### Penny Ferry, The Haling Way

Thank you for the revised plans which you sent us on 3<sup>rd</sup> November. I apologise that we were unable to respond by 5<sup>th</sup> November.

*Image showing the natural desire line for entry to the path, currently blocked by the end car parking bay. Removing that final bay would avoid the need to route cyclists round the back, creating conflict with walkers.*

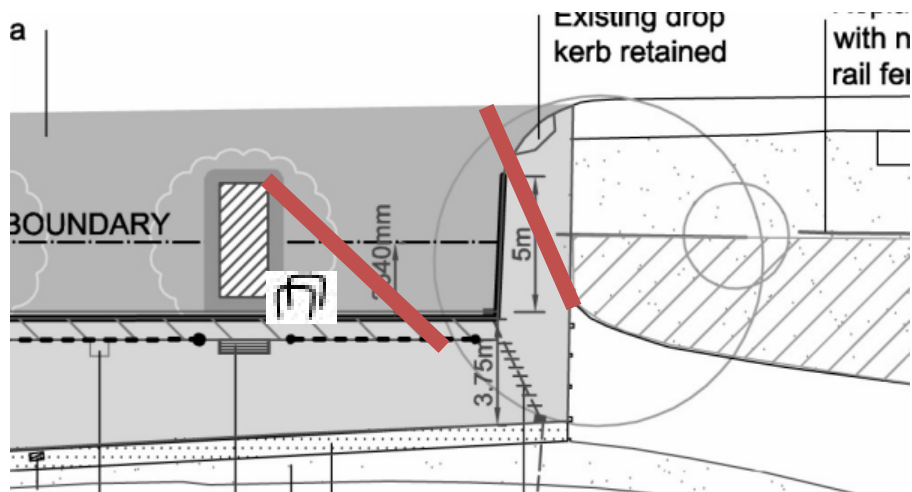
The current plans result in a dog-leg manoeuvre that will create unnecessary conflict with walkers using the path.

The simple way to resolve the problems is by removing one of the four parking bay areas, namely the one nearest to the entry to the path (rightmost in your diagram).

This would mean that the natural diagonal desire line into the path is catered for (see photo), and would make the start of the towpath cycle route look more attractive.

*The thick lines demarcate where the natural entrance to the route would be. Cycle parking could then be installed in the location noted.*

If there is then an argument about the loss of parking, we would point out that there is currently an inequitable situation which the new plans fail to deal with: the complete lack of cycle parking, which is just as important. The corner of the removed bay would create space for this cycle parking, also resolving this problem.
